Outcomes TYNDP 2014 - 2030 Visions - Request for Stakeholder Input Period 3 December 2012-7 January 2013

April 2013

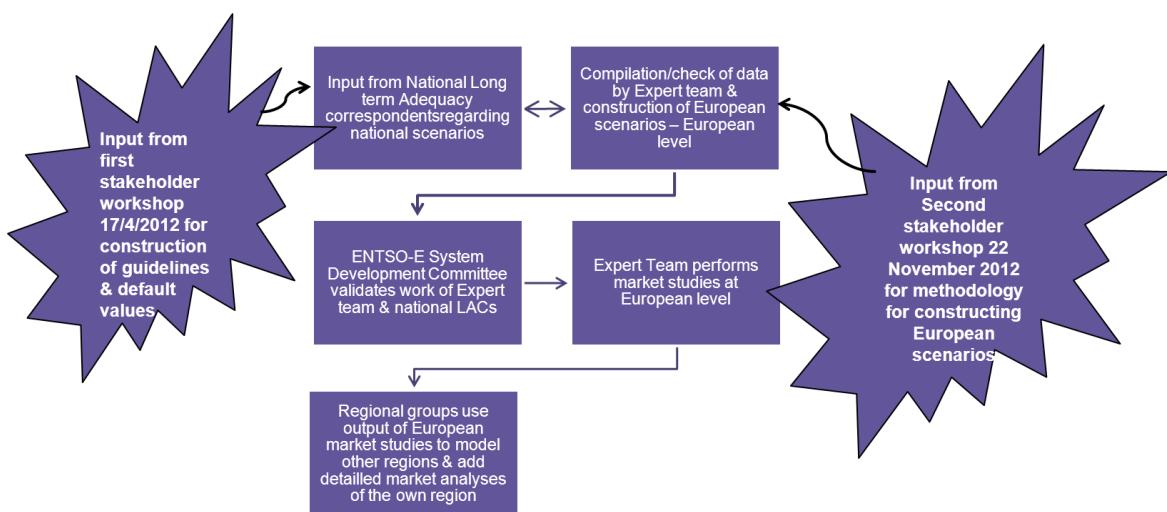
1. First need an accepted approach on how the future production units will develop per country
2. Check the basic production rules on reserve capacity R2 etc. and the market resilience but also demand side actions
3. Decide on which part of generation has to be taken as necessary
4. Check what has to be imported based on load flow and experience in view of outlook scenario's..

As defenders of the development of renewables we also strive to have a sound electrical infrastructure that is able to cope with all grid conditions.

We were surprised to see the demand is still increasing – this should be taken as the not wanted situation as there is the efficiency directive that has to reduce the consumption in terms of 2 to 5%.

Regarding the questions on demand forecast: The higher electric demand levels in vision 3 “Green Transition” and vision 4 “Green Revolution” reflect the idea that several public documents on the topic indicate that in order to achieve the European energy objectives of 2050 a substitution towards electricity is probable. Since the objective of the TSOs is to facilitate the internal European Energy market the likely tendency should be taken into account so TSOs can detect in time the necessary actions needed if these conditions become reality.

Regarding the process: The following figure describes the scenario building and market modelling process in the framework of TYNDP 2012
